CITY OF CONWAY, ARKANSAS PLANNING COMMISSION

October 19, 2026 • 5:30pm • 1111 Main Street

A. Request for preliminary plat approval for Encore Subdivision Phase II (SUB-0926-0141)

A. Request for conditional use permit to allow Community Recreation Facilities in a R-2 zoning district for property located at 424 E 6th St (CUP-0926-0138)

NE terminus of Lewis Ranch Rd, E side of Encore Sub Phase I

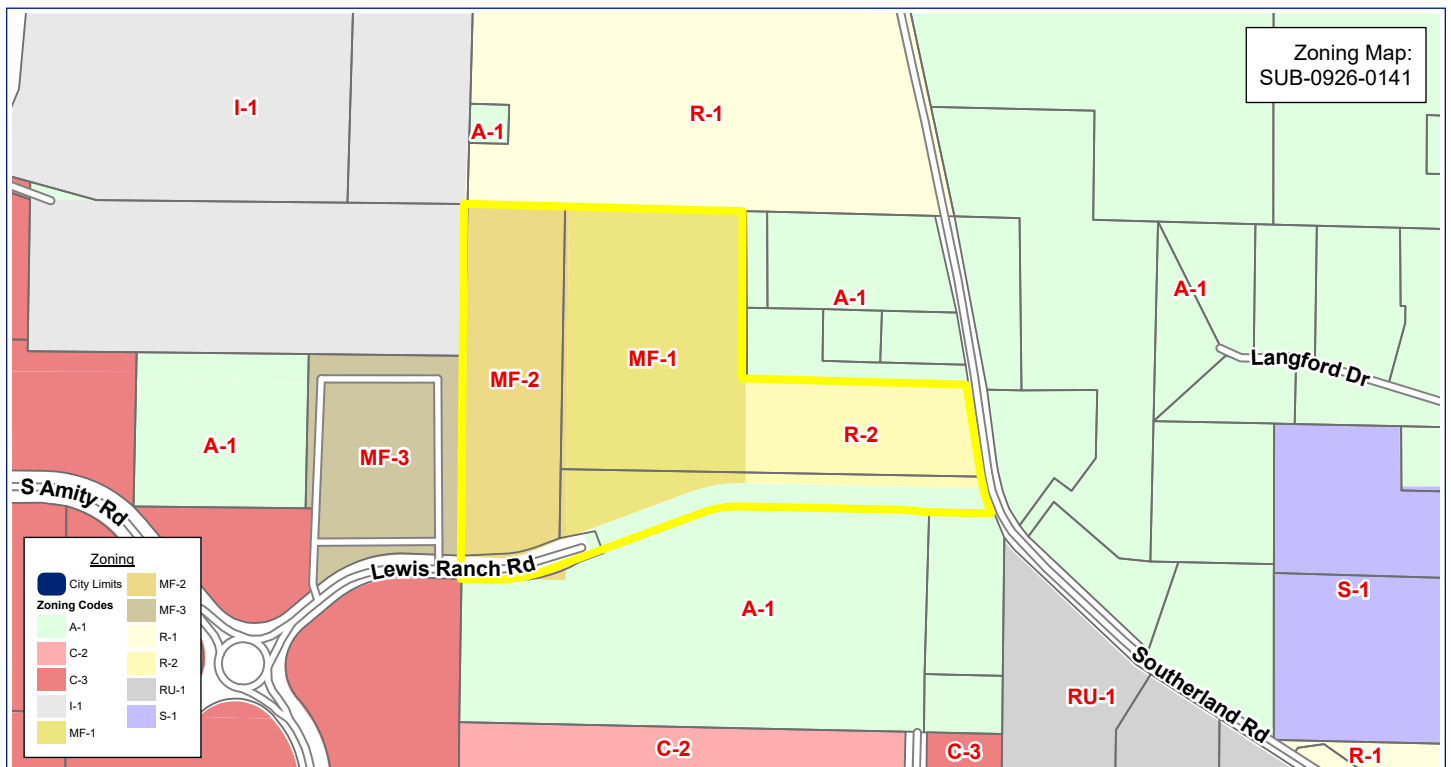
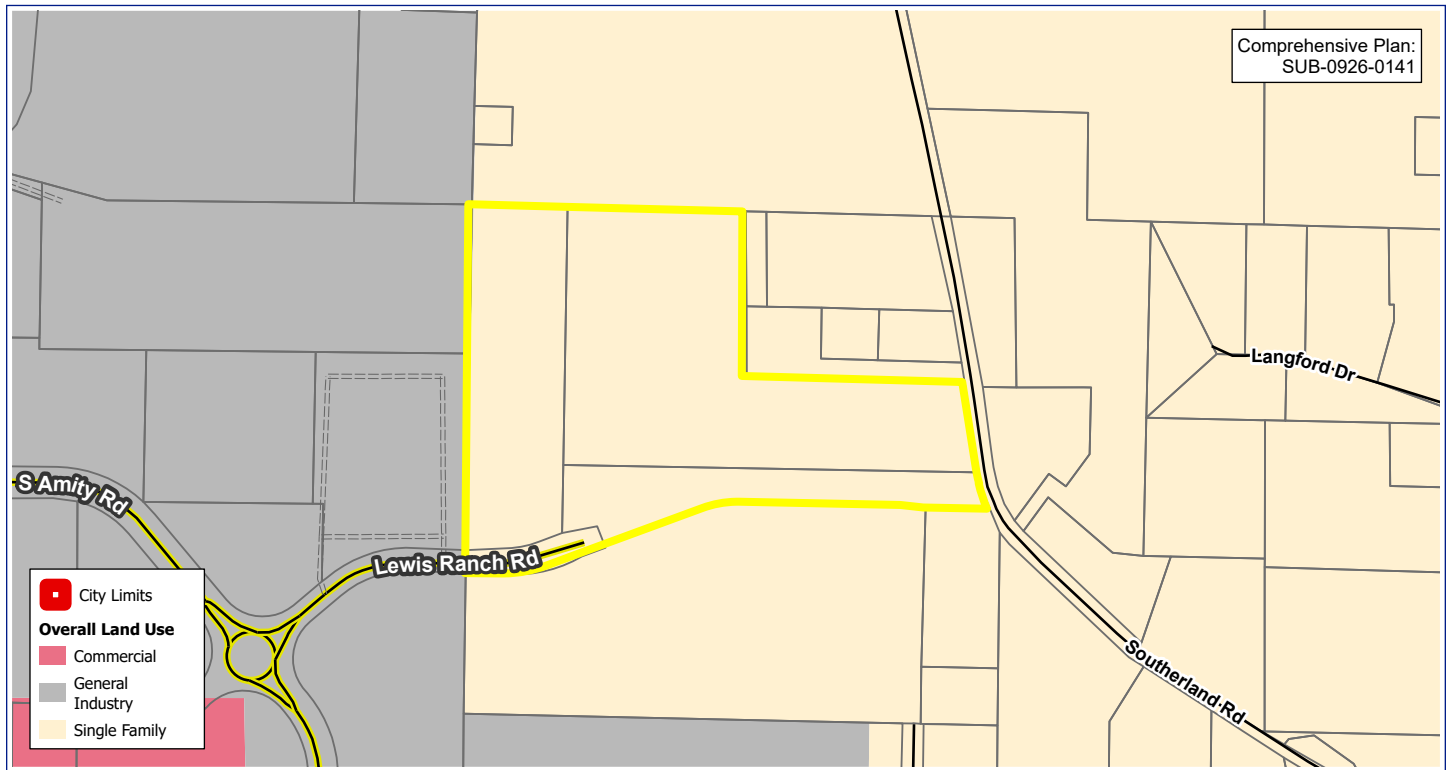
- The applicant is proposing a 2-lot subdivision, with 1 new street being proposed to extend from the existing termination of Lewis Ranch Rd to Southerland Rd.

- Lot 1 will consist of the merging of the Encore at Lewis Ranch Apartments Phase 2 on the western portion, with phase 3 proposed within the remaining portion of the lot. Lot 2 is proposed for residential duplex construction.

- The applicant has indicated that all utilities will be provided by Conway Corporation.
- 60' of right-of-way shall be dedicated along Lewis Ranch Rd.
- Both lots conform to the zoning district requirements based upon acreage, street frontages, and access.

- Addresses will be established prior to the submittal of the Final Plat.
- The developer shall be responsible for the construction of 8' sidewalks along the entirety of Lewis Ranch Rd and portions of Southerland Rd along with the installation of all handicap ramps.

1. Corrections as noted on the Preliminary Plat and Street & Drainage Plans as provided to the applicant in staff review.
2. Show hydrants on plat.
3. Corrections within notes section as relayed to applicant.

1. The Street and Drainage Plans/Drainage Report shall be modified to meet the requirements necessary for approval by the City Engineer prior to final approval of the Preliminary Plat and issuance of an Authorization to Proceed for the installation of improvements. **The developer is not authorized to proceed with any installation of improvements until street and drainage plans have been approved by the City Engineer.**

2. Preliminary Plat approval from all reviewing agencies shall be obtained prior to work commencing.
3. Fire hydrants must be placed so that the furthest point of a lot in a residential subdivision is not more than 600 feet, or 400 feet in a commercial subdivision, from the hydrant located on the same street. Variances must be approved by the Planning Commission and Fire Chief.

4. Utility easements as required by Conway Corporation are needed.
5. Drainage easements as required by the City Engineer are needed.
6. Sidewalks along Lewis Ranch Rd and portions of Southerland Rd frontage shall be constructed by the developer/subdivider.

On the N side of 6th St between 3rd Ave and 5th Ave

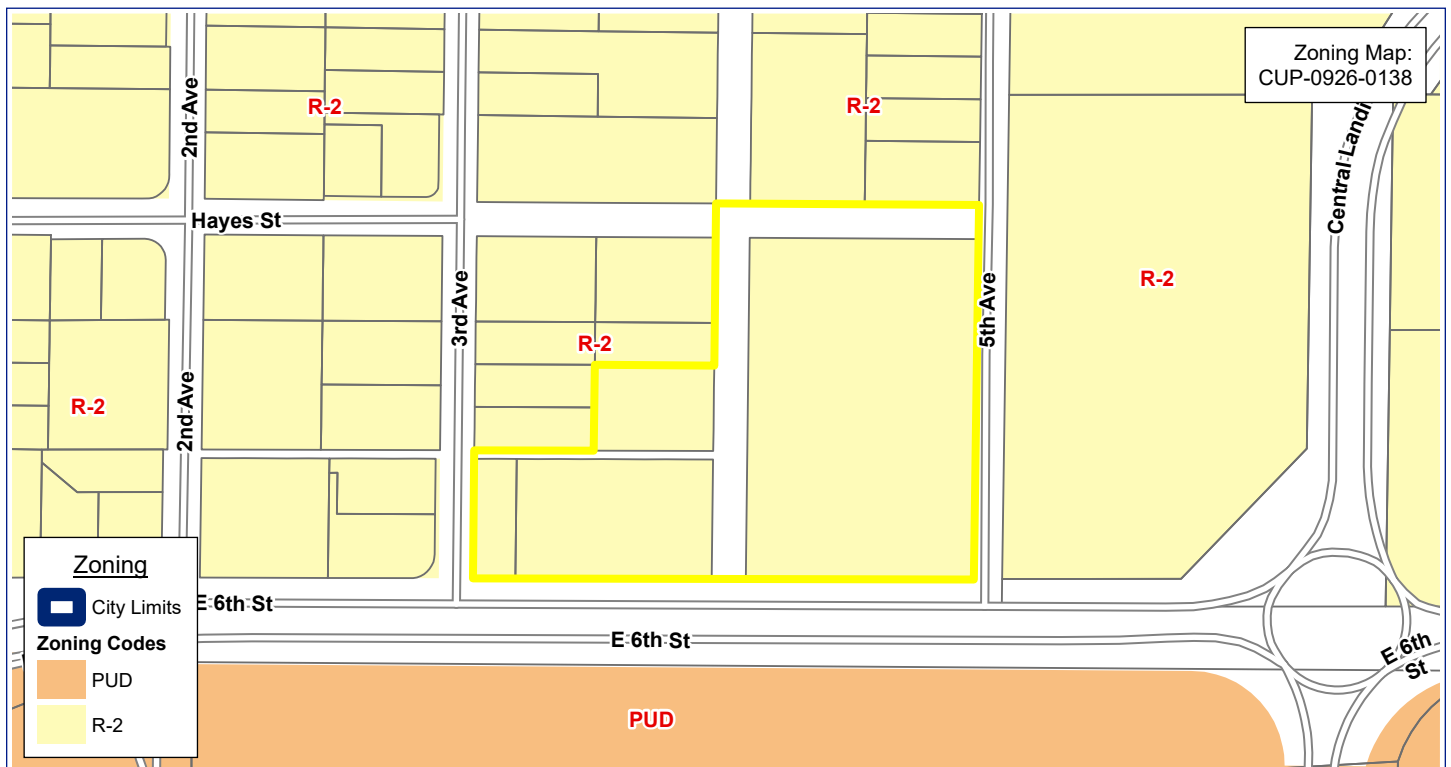
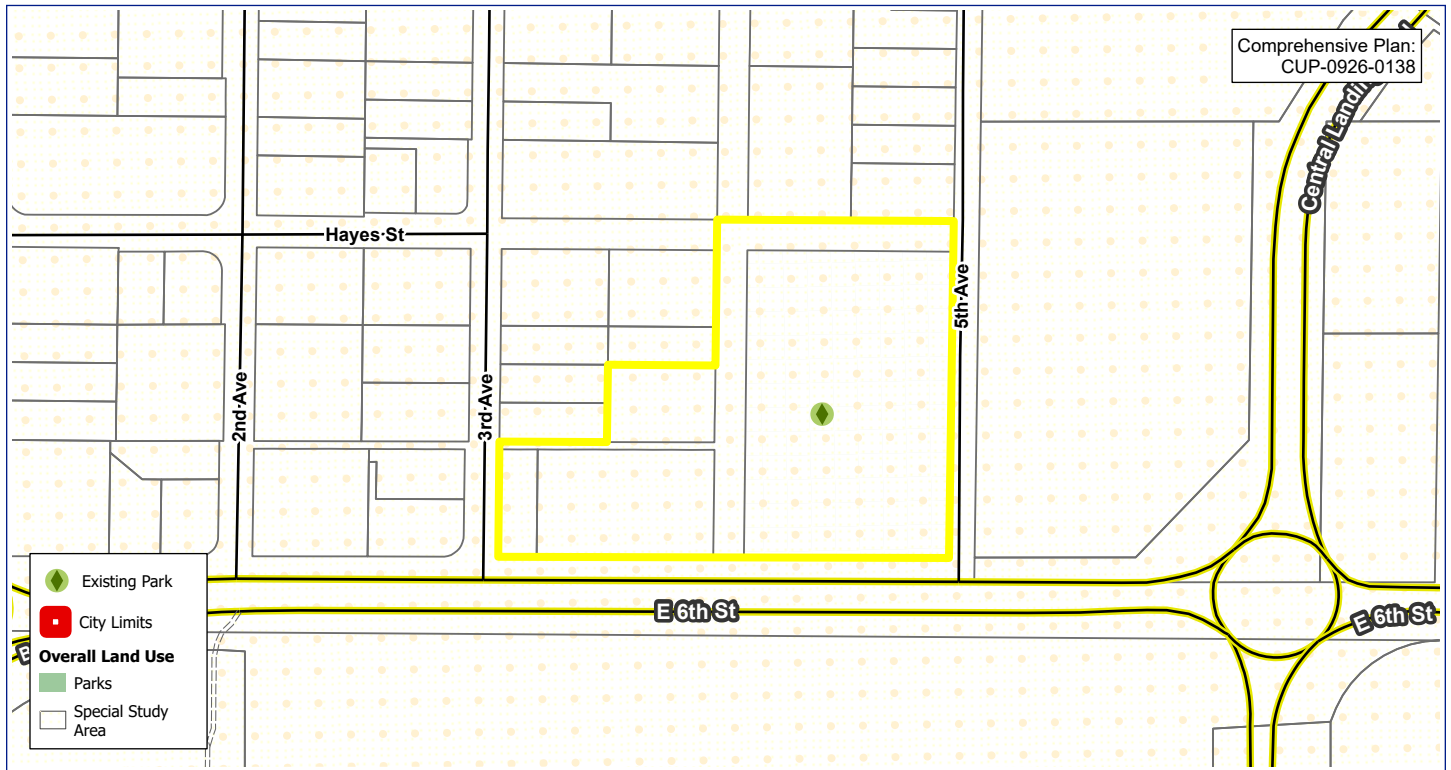
- Recreational Facilities are categorized as Community or Commercial; this project is considered Community. Commercial Recreation Facilities are not allowed in the R-2 zone by right nor by conditional use permit. The following uses are considered Community Recreational Facility uses:

- Day camp, community
 - Park, playground, or tot lot
 - Swimming pool, public
 - Tennis court, public
- The site will undergo Site Development Review as an “Addition to/Change of Vehicular Access” Development Type, in accordance with the Sec. 1002.4 table of the Conway Zoning Code.

- Certain structures, such as dugouts, grandstands, pavilions, and/or restroom facilities, are considered customary in public parks.
 - The City of Conway Zoning Code requires a Variance for commercial accessory structures exceeding 160 square feet.

- The nature of the proposed park does not feature a “primary” structure by which to have an “accessory” structure.
 - As such, said customary structures are considered neither primary nor accessory and will not require a variance permit.

- Customary structures are limited in their function. A restroom facility is customary whereas a concession facility with restrooms and eating areas requires more consideration and would be considered a primary structure. Such a structure may require both site development review and a variance.

1. The following Community Recreational Facility uses, as defined in the Conway Zoning Code, shall not be permitted as part of this conditional use permit:

- Bathing beach
 - Country club, golf course, or private swimming pool
2. The development shall be subject to site development review in accordance with Articles 9 and 10 of the Conway Zoning Code.

3. Vehicular access to the site shall not come directly from 6th St.
4. Customary park structures, such as dugouts, grandstands, open-air pavilions, and/or restroom facilities, shall abide by all adopted building, fire, and zoning code standards; such structures shall be allowed as part of this conditional use permit and will not require a variance.

5. Signage shall be allowed to conform to Section 1205.3 – Commercial, Office, Institutional, and Industrial Zones of the Conway Zoning Code.
6. No zoning variance, which could result from the commencement of the conditional use, may be considered.

7. Development of this site is intended to be in two phases. Any expansion of the approved use, within the boundaries established by this conditional use permit, shall not require an amended or new conditional use permit. Any new use(s) not covered by the “Recreational Facilities, Community” use and/or any future expansion to new or additional property shall require an amended or new conditional use permit.

8. This conditional use permit shall become null and void if the ownership changes from the City of Conway or a related public entity.
9. The conditional use permit shall expire if the use ceases for a consecutive period of greater than 18 months.
